SLIDING DOOR– INTERIOR POST FINISHING TRIMS Prevost vehicles

DESCRIPTION

On the vehicles affected by this bulletin, replace the sliding door interior post finishing trims as described in the following procedure.

FIGURE 1

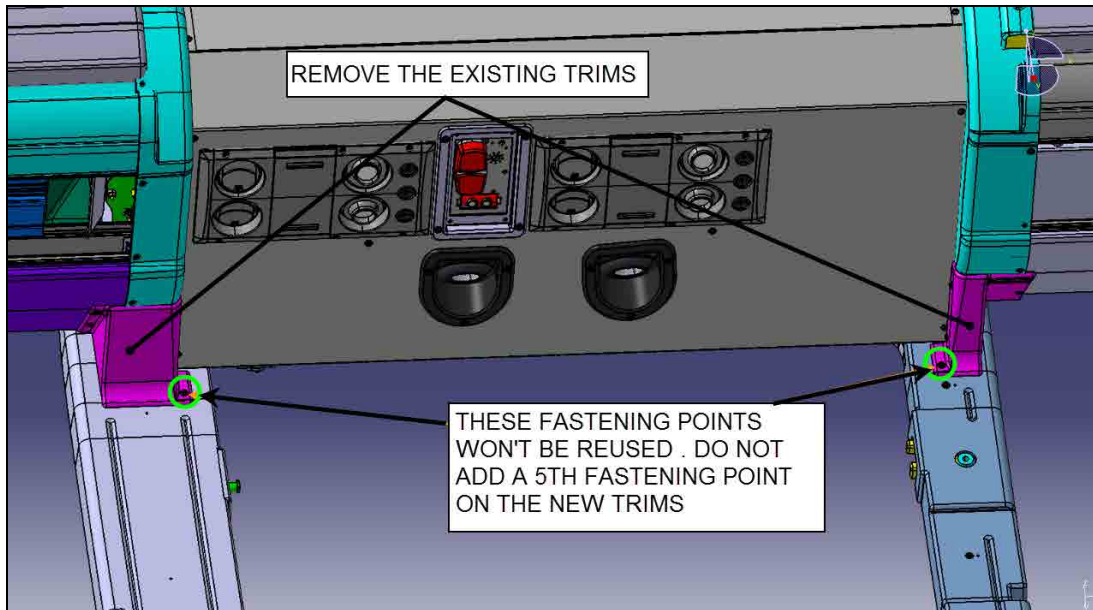
- 1) Remove the finishing trims shown on figure 1.

FIGURE 2: TRIM 314471, WITH 4 FASTENING POINTS

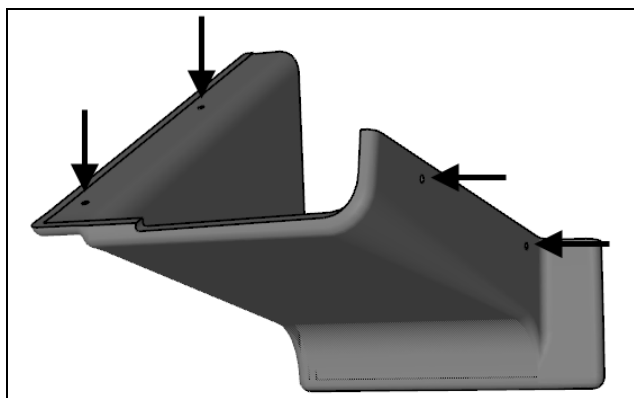
- 2) Install the new finishing trim similarly. Take note that each finishing trim has four fastening points instead of five like the previous version.
